Supporting Documentation

Guilden Sutton St John – Heating

Gas Boiler Replacement – Need, Option Appraisal and Proposal

St John's west aspect and proposed location of new flue pipe (blue)

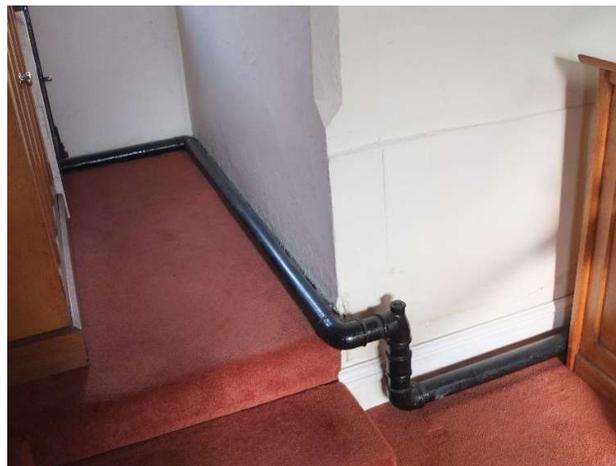
<p>06/04/2021 To: Katy Purvis From: Peter Reid</p>	<p>I thought I had completed all the sections of the online application (accepting that the statement of significance was a file which I sent you). Could you let me know what else I need to do? I've just clicked a 'submit' button - maybe that was all that I needed to do?</p>
<p>06/04/2021 To: Peter Reid From: Katy Purvis</p>	<p>Yes, that's right, you just needed to submit it, all sorted now</p>
<p>06/05/2021 To: Peter Reid From: Caroline Hilton</p>	<p>I have been working on raising the Notification of Advice, and this is nearly ready now. I'd be grateful if I could just check one detail with you. I note from the details the new flue exit position is marked on a photograph but I don't have any detail of what the flue will look like. I've googled the proposed <i>Worcester-Bosch 30kw Greenstar Life 8000 A</i> rated condensing boiler and can see that in some of the promotional images that come up, the flue attachment is included next to the boiler. (Please see link to example Worcester Greenstar 8000 Life Regular Boiler Packs horizontal flue PlumbNation)</p> <p>Am I right in assuming it would be like the example in the link, with a wire guard over it?</p>

<p>06/05/2021 To: Caroline Hilton From: Peter Reid</p>	<p>Yes, my understanding is it is a round pipe, with a cage over it. We have a Worcester Bosch boiler at home (fitted by the same</p>

<p>engineer who is going to do the church) and our flue looks exactly like the picture I'll attach. I think the church's will be similar.</p>
--	---

Figure showing proposed location of new boiler (green rectangle), flue (blue rectangle) and the root of the condensate drainage pipe (red line) on the back wall of the vestry, behind the cupboards, before emerging at the location of an existing drain.

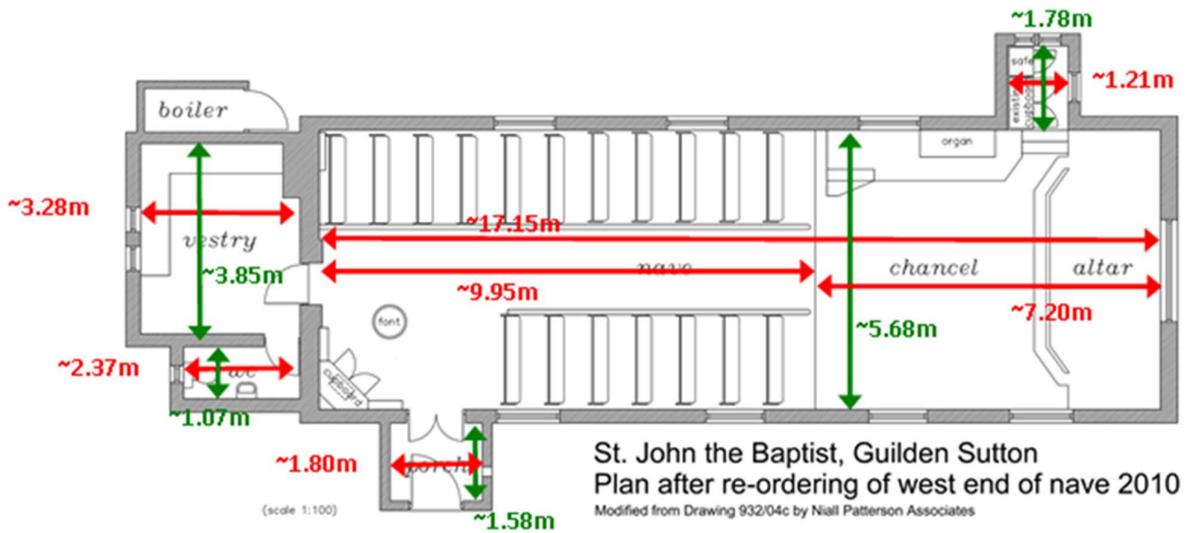
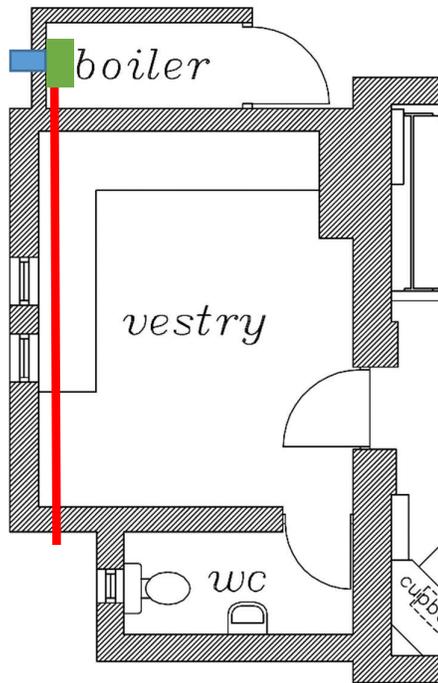
09/03/2021 To: Peter Reid From: Katy Purvis	I've just had a query from the architect reviewer, which I admit I should have spotted myself. Has Tony been involved in the actual proposals rather than just the net zero aspect? Is he supportive of the boiler location, drainage etc?
09/03/2021 To: Katy Purvis From: Peter Reid	No we haven't involved him in that as there didn't seem a need.
09/03/2021 To: Peter Reid From: Katy Purvis	He might not need to do much, but he will need to be involved regarding location etc, so please could you contact him? I'm afraid I've also realised this needs faculty rather than List B, because the boiler location isn't as existing, sorry. I've put it on the agenda for the next DAC meeting 26 th March anyway.

<p>09/03/2021</p> <p>To: Katy Purvis From: Peter Reid</p>	<p>I didn't realise that moving it a few feet in the boiler house constituted a new location. I'll contact Tony.</p>
<p>09/03/2021</p> <p>To: Katy Purvis From: Peter Reid</p> <p>With attachment</p>	<p>I have started the faculty form. BTW do we need more than one petitioner?</p> <p>I'll attach the statement of significance which I already have.</p> <p>2) Statement of significance</p>
<p>11/03/2021</p> <p>To: Peter Reid From: Katy Purvis</p>	<p>Hi Peter, thanks for this statement of significance, and for starting the application. I think it's fine to have just one petitioner</p> <p>I've heard back from the heating advisor he comments "I have reviewed the information that you have sent through and have the following comments:</p> <p>The gas consumption is low at approximately 24000 kWh (2019 figure). The Parish have put forward a good submission to demonstrate that replacing the existing inefficient boiler with a new condensing boiler is the correct approach. On this basis I would expect their gas consumption (and carbon emissions) to fall whilst maintaining the same internal conditions.</p> <p>I would like the Parish to commit to looking closely at the potential for any fabric thermal performance improvements. This may be in the long term when any major work is undertaken. One particular area may be to consider is if the access doors and windows are suitably draught proofed. This is relatively inexpensive to undertake and will give an immediate benefit.</p> <p>My only comment on the detail of the proposal is that the boiler is shown above the access stair to the boiler room. This is a difficult location for access both for maintenance and the user (to adjust the controls). My understanding is that this arrangement would not be in-line with the manufacturers installation instructions. I would be grateful if the Parish could review the location with the boiler specialist and advise."</p> <p>Please could you respond to the third and fourth paragraphs, probably with advice from Tony as well as your heating contractor? Tony will be able to advise as to whether draught proofing is appropriate, and may well have a view on the boiler location</p>

<p>Regarding the boiler location - in the first instance I have discussed this with the heating engineer who suggested the location. He clarified that the reason he didn't want to put the replacement in the location of the existing boiler down in the boiler house is because there would be no easy flue solution. He does not see access to the boiler in the proposed new location as problematic. I have been down to look at the location more closely today and attach two photographs taken standing on the second step up from the stairwell floor. I was eye-level with the proposed boiler location and had no difficulty touching the back wall. Since the boiler will protrude from that wall I see no problem in accessing it. Our heating engineer did say we could construct a simple wooden platform resting on the steps and stairwell if that proved necessary - but I don't think it will be. He was not aware of a reason why the proposed location should contravene the manufacturers instructions but he asked me if we could ask the Diocesan heating adviser what his specific concern was so that can be addressed. Therefore I should be very grateful if you would kindly forward this question</p> <p>8) Photographs of boiler location</p>

<p>15/03/2021</p> <p>To: Peter Reid From: Katy Purvis</p>	<p>I have a further response from our heating advisor</p> <p>"I am happy that they are looking at the draught proofing.</p> <p>Regarding the boiler location below is an extract from the manufactures instructions:</p> <p>1</p> <hr/> <p>The appliance must be installed where:</p> <ul style="list-style-type: none"> ▶ The area is well lit, allowing to clearly see the appliance to carry out any work or checks. ▶ An engineer can gain clear and safe access to work on the product or component, including making adequate provision for visual inspection of flues in voids. ▶ The homeowner can gain clear and safe access to the controls, check, top up or reset the appliance. ▶ Roof space installations must fully conform to BS 5410 part 1: roof space installations. ▶ Products in roof spaces must have permanent fixed lighting, a permanent fixed retractable ladder and a fixed floor area sufficient to allow access for normal use and servicing around the product and between and the access hatch. <p>We would also recommend that a remote pressure gauge and filling loop are sited where the customer can gain easy access for checking and topping up.</p> <hr/> <p>There should be arrangements to 'allow access for normal use and servicing of the product'.</p> <p>The provision of a removable platform will make servicing the boiler much easier and I would recommend this is considered. If the Parish and Heating Installer are satisfied the arrangements provided are suitable then I have no further comments."</p>

<p>22/03/2021</p>	<p>I discussed our heating with Tony Barton on Friday including the proposed location for the new boiler and the route of the condensate</p>

<p>To: Katy Purvis From: Peter Reid</p>	<p>drain pipe. He expressed no concerns. I also raised with him the issues of draft proofing and insulation and we will consider these further.</p>
<p>06/04/2021 To: Peter Reid From: Katy Purvis</p>	<p>With apologies for the delay, Caroline is on leave, and I was off sick last week.</p> <p>I'm writing to let you know that the DAC considered the proposal for a new boiler at its meeting of 26 March 2021 and resolved, subject to submission of a formal faculty application, to recommend the scheme, with the following provisos</p> <p>a. Any electrical works should be carried out by an electrical contractor accredited with the NICEIC or ECA, to the standards recommended in the Churchcare "Guidance Note: Electrical Wiring Installations in Churches" available via https://www.churchofengland.org/sites/default/files/2018-11/CCB_Electrical-wiring-installations-in-churches_Apr-2013.pdf</p> <p>This means that if you now complete an online faculty application, when Caroline returns from leave, she will be able to raise the Notification of Advice so the public notices can be made available for display.</p> <p>If you have any queries please let me know.</p>
